Mandalong Southern Extension Project Modification 4 - Extension of Longwalls 22 and 23 (SSD 5144 MOD 4)

Environmental Assessment Report Section 96(2) of the *Environmental Planning and Assessment Act 1979*

Figure 2: Approved and proposed longwall layout

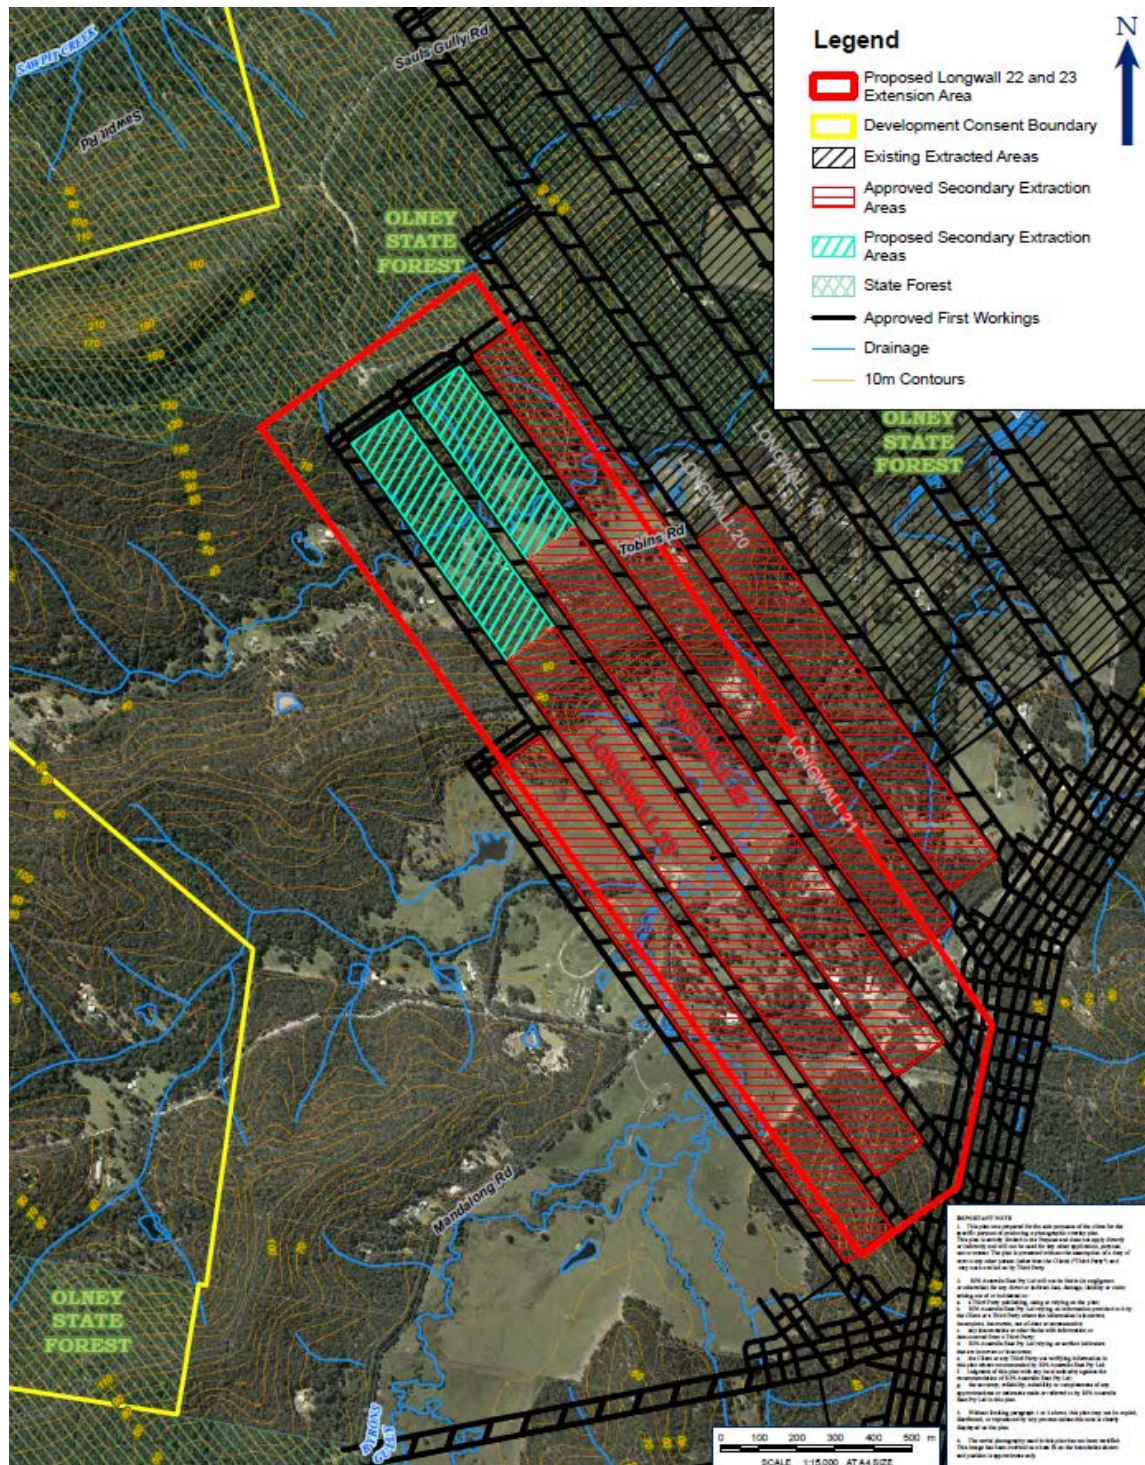
An igneous sill lies to the west of existing longwall panels 22 to 24. Due to previous uncertainty over the extent of this sill, these panels were first designed to be shorter to avoid the sill impacting on the mine's production. However, due to ongoing geological exploration and successful extraction of adjacent panels below the sill, its extent has become better understood.

In effect, the modification would allow an extension of mining in the West Wallarah Seam and would utilise the existing underground workforce and mining equipment. No changes are proposed to the approved mine life, extraction rate, delivery limits, hours of operation or site infrastructure (including ventilation systems). In addition, the proposed mining extension would be within the existing Project Application Area (see **Figure 2**).

Figure 3 – Predicted vertical subsidence, tilt and strain at the end of Longwall 23
 Note: Longwall 23 is the most southerly longwall in this figure.

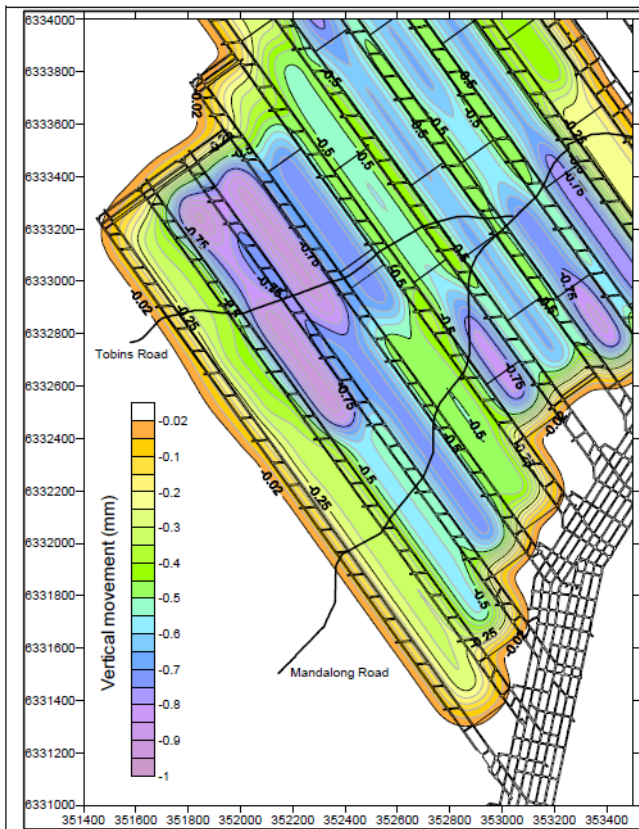
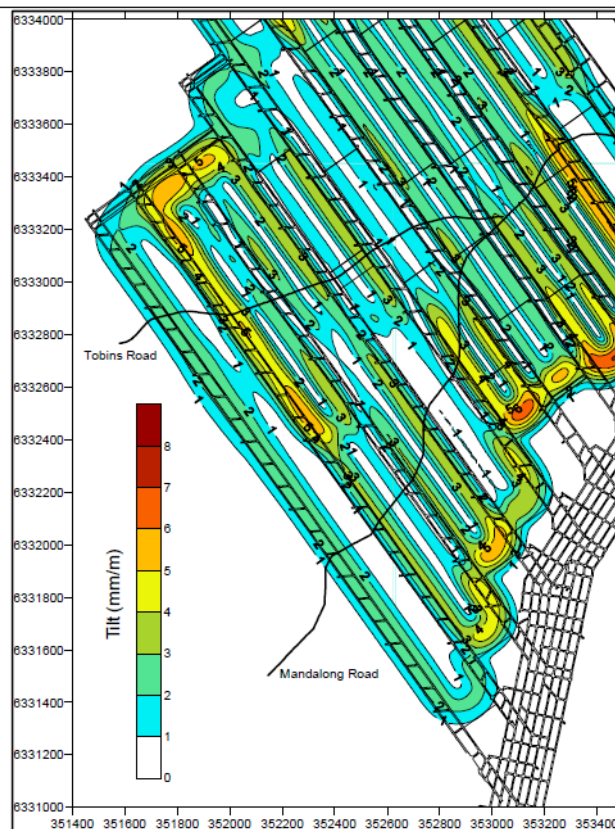
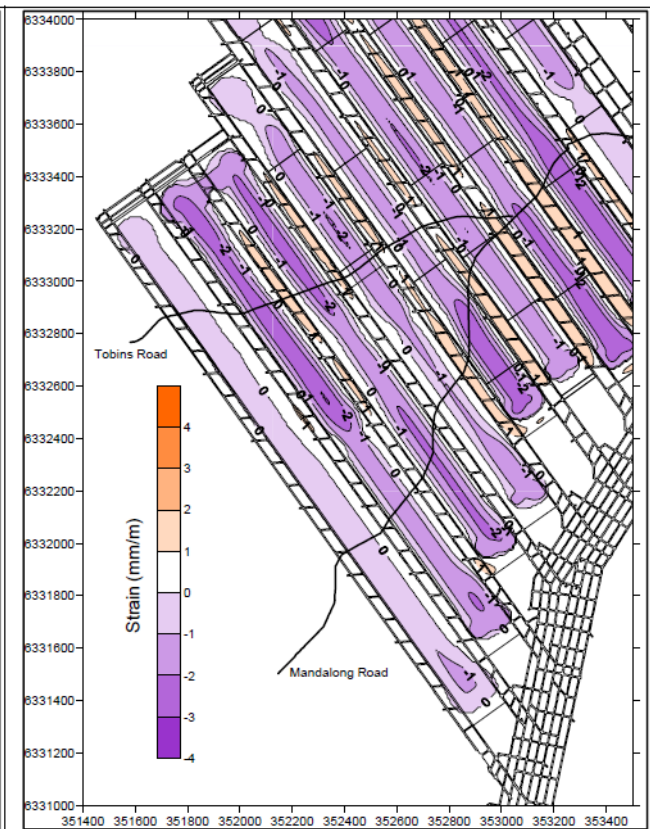
The maximum predicted values for all parameters occur above the north-western end of Longwall 22 (see **Figure 3**).

The SA notes that it is unlikely that any tensile cracking or compressive buckling will develop in soil or rock. Additionally, due to the low values of tilt and strain, no significant far-field subsidence or 'upsidence' impacts are predicted to occur.
